## Product Change Notification - SYST-11ALNE662

ERRATA - dsPIC33CH512MP508 Family Silicon Errata and Data Sheet Clarification

**Description of Change:** 1) Added silicon issue 21 (I2C).

## dsPIC33CH512MP508 Family Silicon Errata and Data Sheet Clarification

**FIGURE 1-1: I/O RAMP**

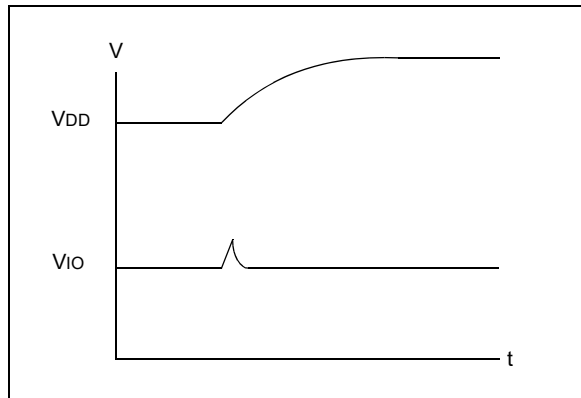
During a fast device power-up, when the VDD ramp is less than 4 mS, the I/O pins may drive up to 100  $\mu$ A current for a duration of up to 10  $\mu$ S (Figure 1-1).

1. Slow down the VDD ramp time (greater than 4 mS for VDD to ramp 0V to 3.3V).
2. Ensure the circuitry that is connected to the pins can endure this pulse.

Example applications affected may include complementary power switches, where a transient current shoot-through might occur. High-voltage applications with complementary switches should power the high-voltage 200  $\mu$ Sec later than powering the dsPIC<sup>®</sup> device to avoid the current shoot-through. This behavior is specific to each device and not affected by aging.
